CITY OF PUNTA GORDA ADA TRANSITION PLAN FINAL REPORT City Hall

October 4, 2017

City of Punta Gorda 326 West Marion Avenue Punta Gorda, Florida, 33950

Figure 4-6 – Emergency Exit Stairs 1

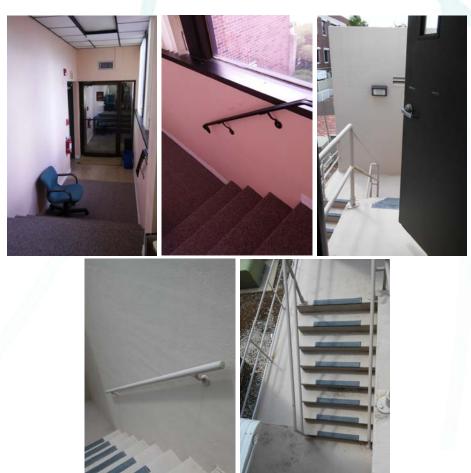
- Stairway 1 serves as an emergency exit. This exit is not signed appropriately with an illuminated sign or a tactile exit sign prescribed by **ADAAG 216.4.1**.
- The handrails along Stairway 1, which serves as an emergency egress do not have adequate 12" handrail extensions, not meeting **ADAAG 505.10.1.**
- There are several additional exit doors that are missing tactile exit signs, not meeting ADAG 216.4.1.
- There are several doors throughout the facility serving as exit doors that are identified with exit signs that are not illuminated, including inside the front entrance.

Note: At the time of construction and alterations performed at the City Hall facility, the requirement to provide a tactile exit sign at egress doors was not included in the code. However, current ADAAG standards stipulate this requirement and we are recommending the following.

- Add an illuminated exit sign above the doorway to Stairway 1, along with a tactile exit sign, complying with ADAAG 703.1, ADAAG 703.2, and ADAAG 703.5, adjacent to the doorway.
- Modify the handrails along Stairway 1, both internal and external, so that there is adequate 12" handrail extensions complying with ADAG 505.
- Ensure that that exit doorways have tactile exit signs complying with ADAAG 703.1, ADAAG 703.2 and ADAAG 703.5.
- While not an ADA violation, illuminated exit signs should be installed instead of the existing non-illuminated variety currently installed.
